VALUE ENGINEERING STUDY

**Project # STP00-0065-02(013) PI No. 621490-
SR 53 Bu from SR 515/APD to CR 243/Industrial Blvd
Pickens County, Georgia**

Reference: VE Workshop – SR 53 Bu from SR 515/APD to CR 243/Industrial Blvd.,
Pickens County, GA
Project #: STP00-0065-02(013) - PI#: 621490-

PROPOSED CHANGE SKETCH/DETAIL

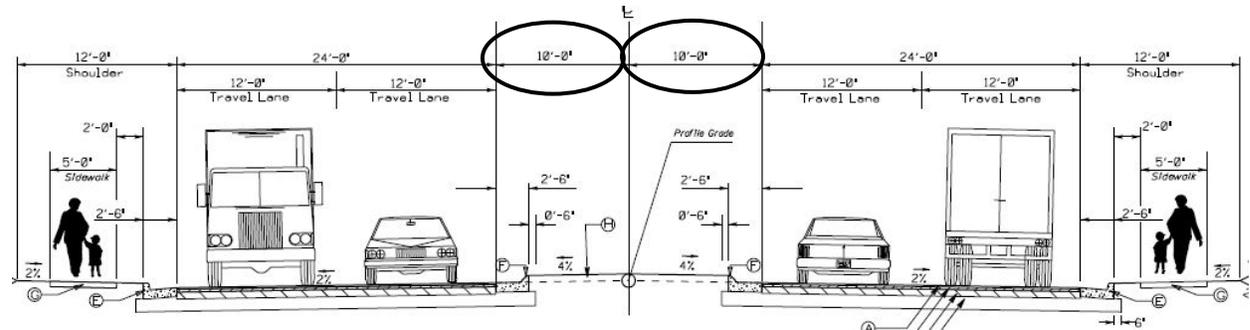
PROPOSED CHANGE: It is proposed to reduce the raised median width to 16 ft. in lieu of 20 ft. This reduction requires a design variance but these have been commonly granted by GDOT in the recent past, especially on projects such as this with no drainage structures in the median.

Proposed Change: Reduce 20'0" median to 16'0"

PROPOSED CHANGE SKETCH/DETAIL

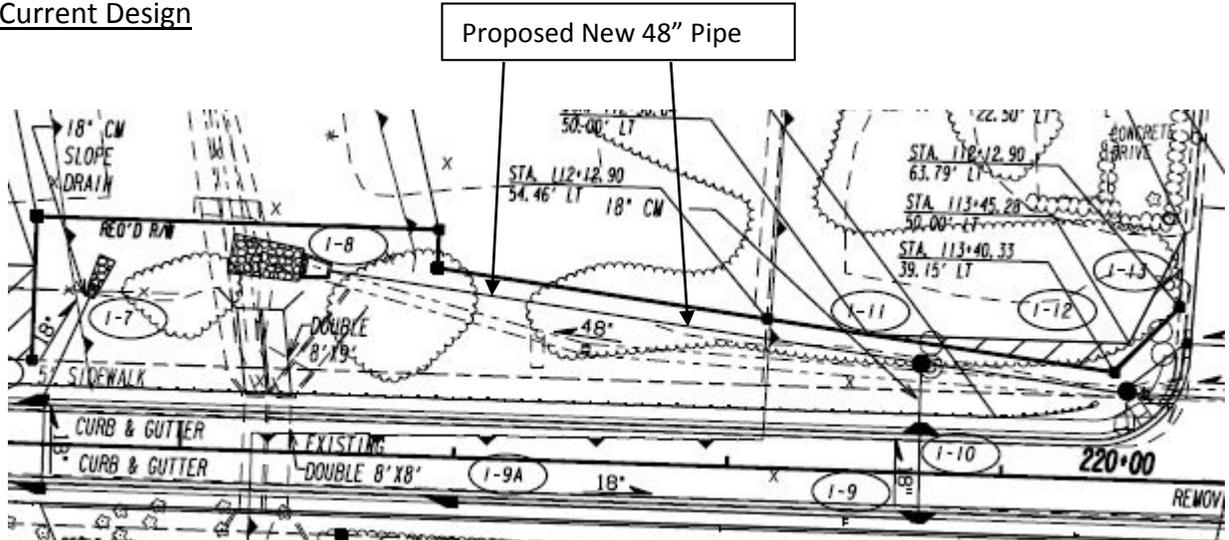
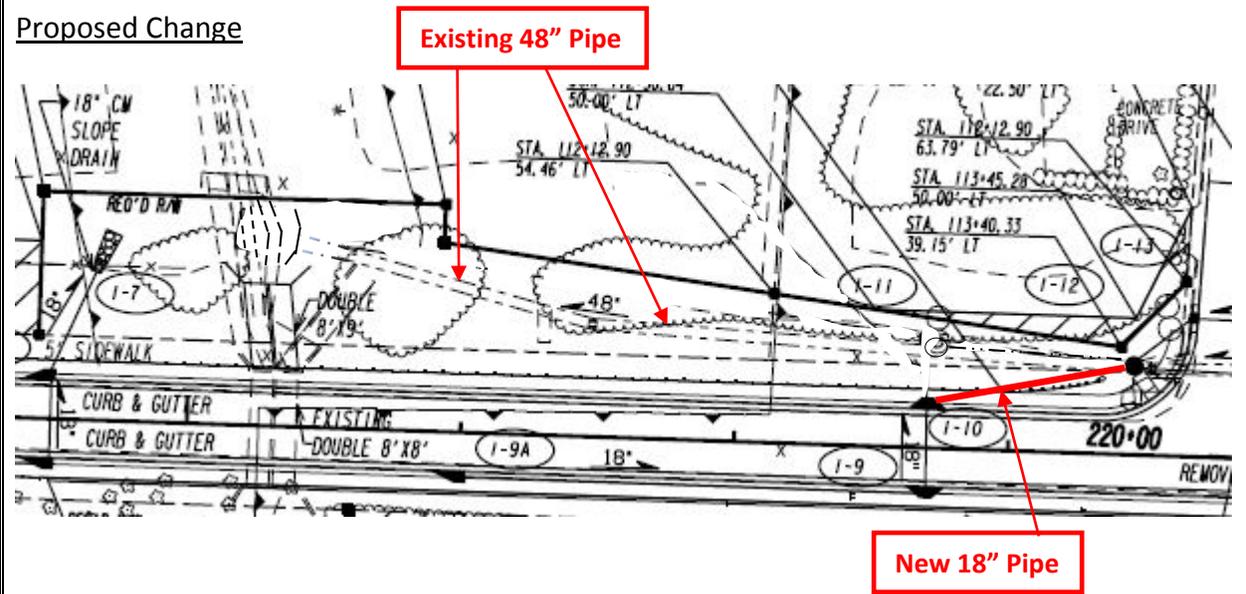
PROPOSED CHANGE: It is proposed to use the existing 48" SDP and eliminate the new 48" pipe from I-12 to I-8. Route a new 18" SDP from I-10 to I-12 in lieu of I-11, and eliminate the proposed new junction box I-11.

Proposed Change: Utilize the existing 48" pipe in lieu of placing new pipe from I-12 to I-8. Route new 18" pipe from I-10 to I-12 and eliminate new junction box I-11.

PROPOSED CHANGE SKETCH/DETAIL

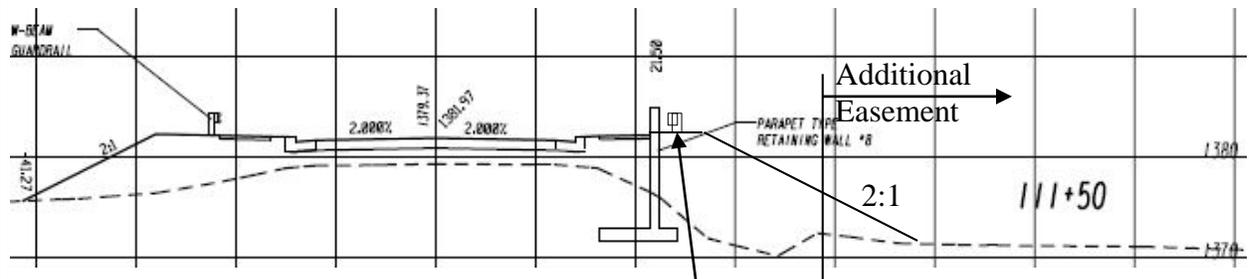
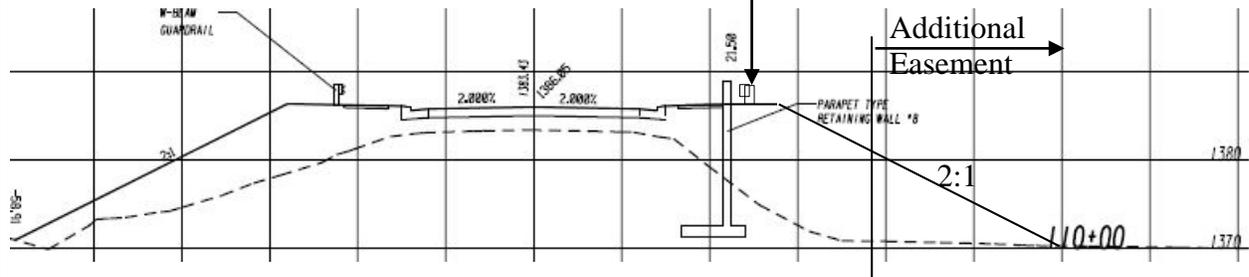
PROPOSED CHANGE: It is proposed to eliminate Wall #8, install a guardrail and slope to existing grade. Additional Easement will be required.

Proposed Change: Eliminate Wall #8, install guardrail and Slope 2:1 to Existing Grade

Eliminate wall and install guardrail

PROPOSED CHANGE SKETCH/DETAIL

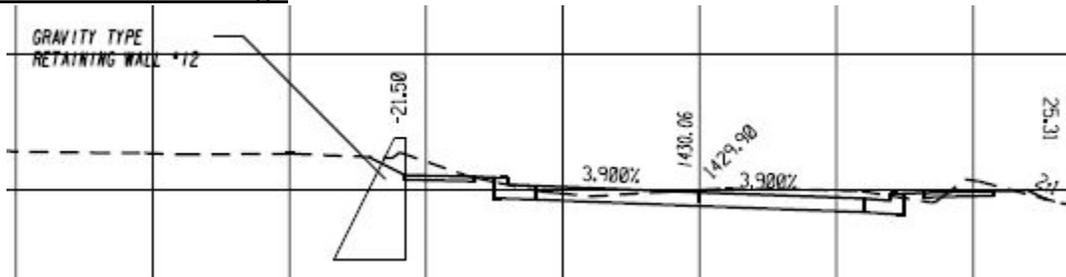
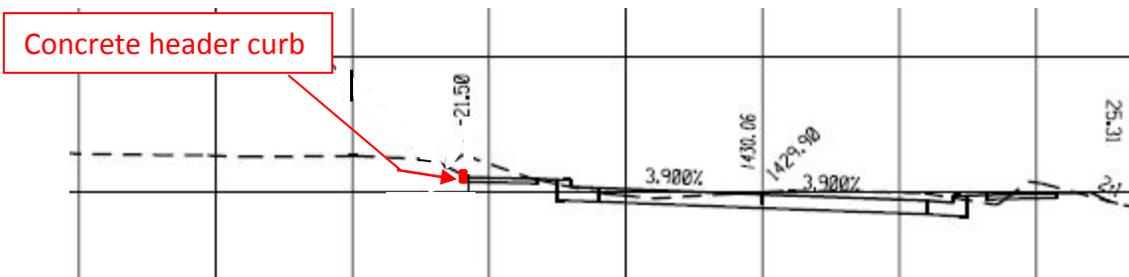
PROPOSED CHANGE: It is proposed to use concrete header wall in lieu of Wall #12 and then slope to proposed sidewalk. Additional ROW or easement will not be required.

Proposed Change: Eliminate Wall #12 and Utilize Concrete Header Curb

PROPOSED CHANGE SKETCH/DETAIL

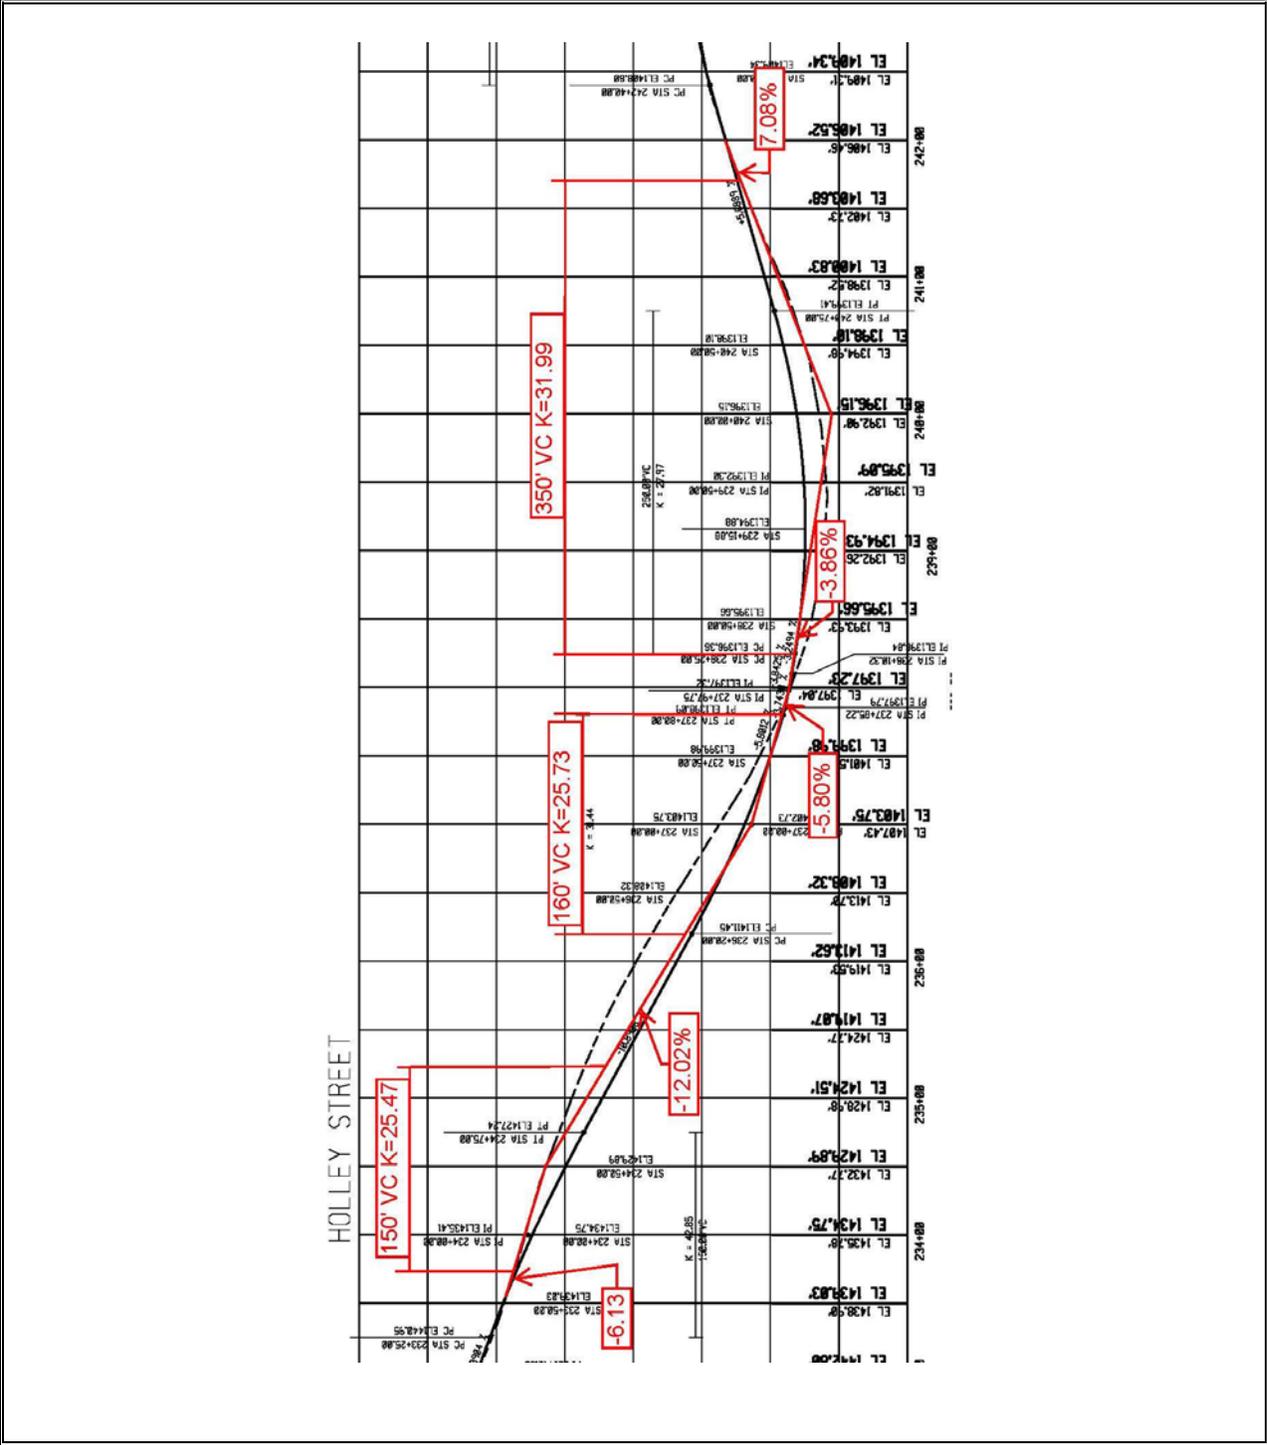
PROPOSED CHANGE: It is proposed to begin work on Holly Street at Sta 233+75 and end work at Sta 242+00. The existing approach grade is -11.56% and would be increased to -12.02% and then an exiting grade of -5.80% as it approaches the proposed intersection with SR 53 Bus Westbound. After the intersection an approach grade of -3.86% will meet an exiting grade of +7.08% to tie into the existing roadway at Sta 242+00. A grade of 11% for rural two-lane roads is allowable with an additional 1% for short distances and low ADT. The 12.02% grade is for 250-ft. The proposed change will reduce 425 LF of milling and overlay along the existing road.

ORIGINAL DESIGN SKETCH/DETAIL

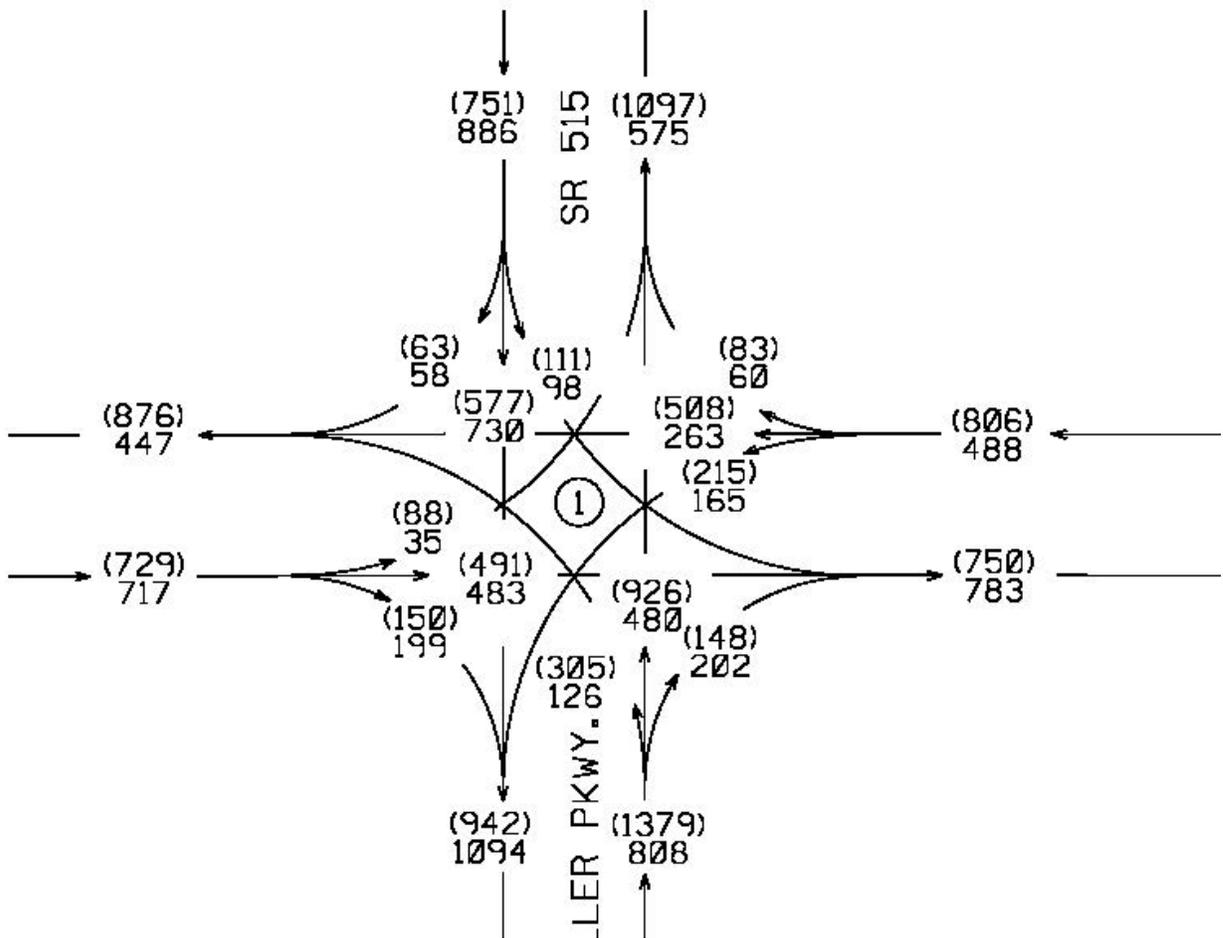
PROPOSED CHANGE: Based on the recent updated traffic counts, it is proposed to reduce the dual left turning lanes in both directions to one left turning lane and limit construction on the west side of SR 515 to only extending the right turn lane from SR 53 onto SR 515 southbound.

The intersection will be more efficient in the off peak hours without the dual lefts, as the left turn movements will be permissive or protected permissive movements. As designed, dual left turn movements must operate in protected-only mode, requiring both additional green time to be taken away from the main street and higher cycle lengths during off-peak timing plans.

PROPOSED CHANGE SKETCH/DETAIL

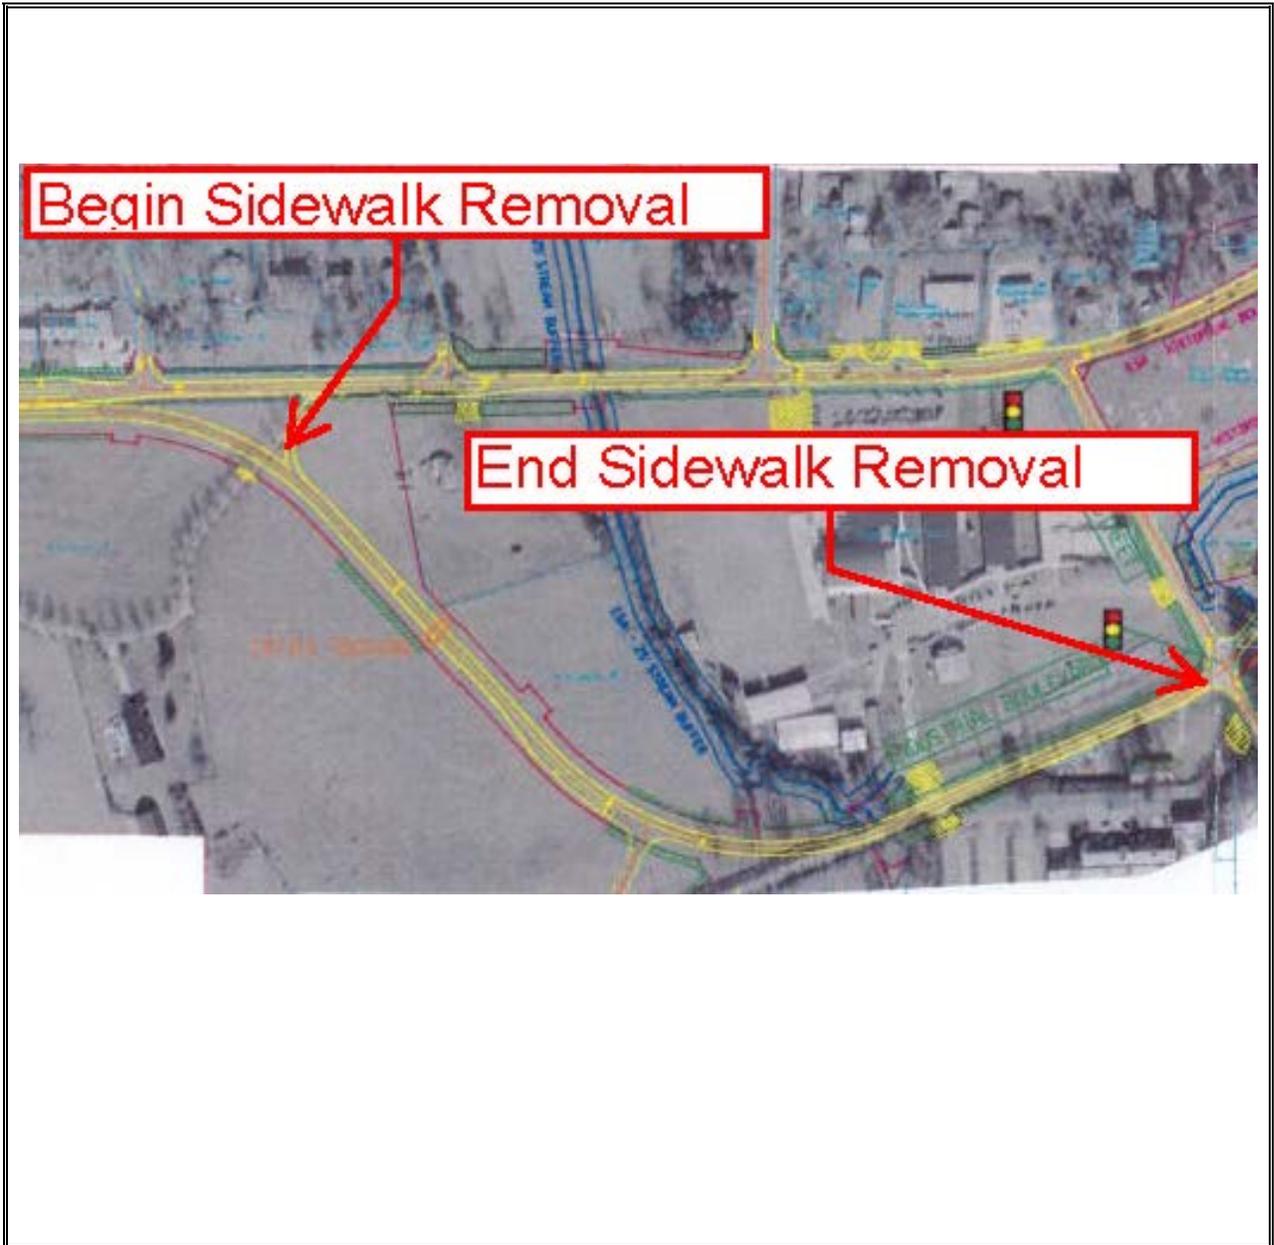
PROPOSED CHANGE: It is proposed to remove sidewalk from the two-way split to Holly Street on the north and south side of SR 53 eastbound.

ORIGINAL DESIGN SKETCH/DETAIL

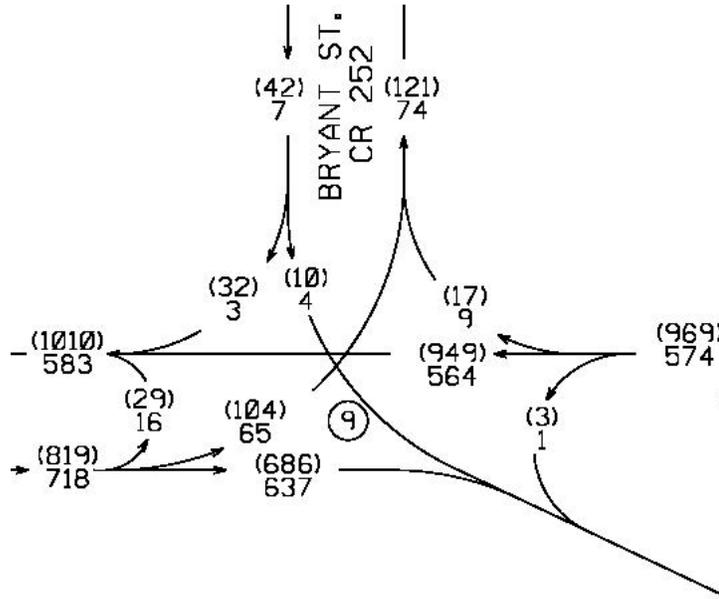
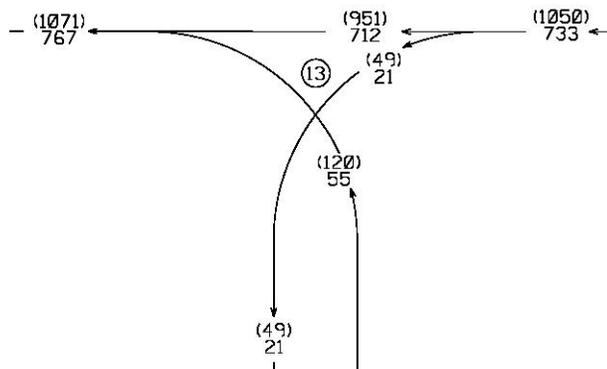
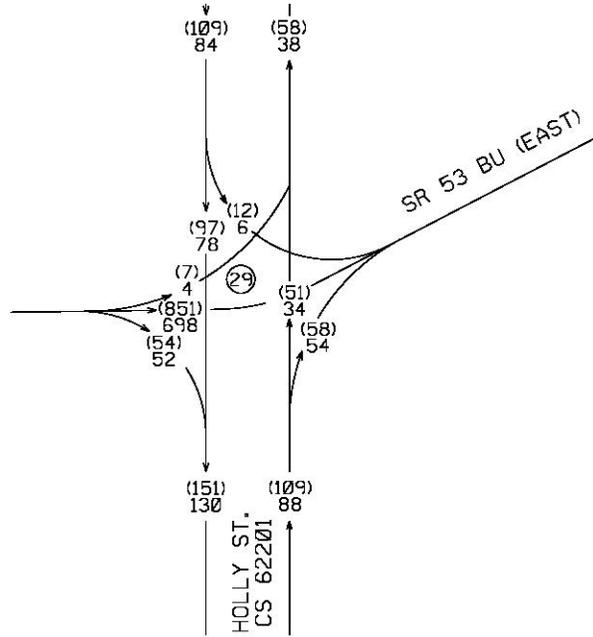
PROPOSED CHANGE: Based on the recent updated traffic counts (see design hourly volumes on the sketch pages), it is proposed to remove the signals at Bryant Street at SR 53, Holly Street at SR 53 westbound and Holly Street at SR 53 eastbound.
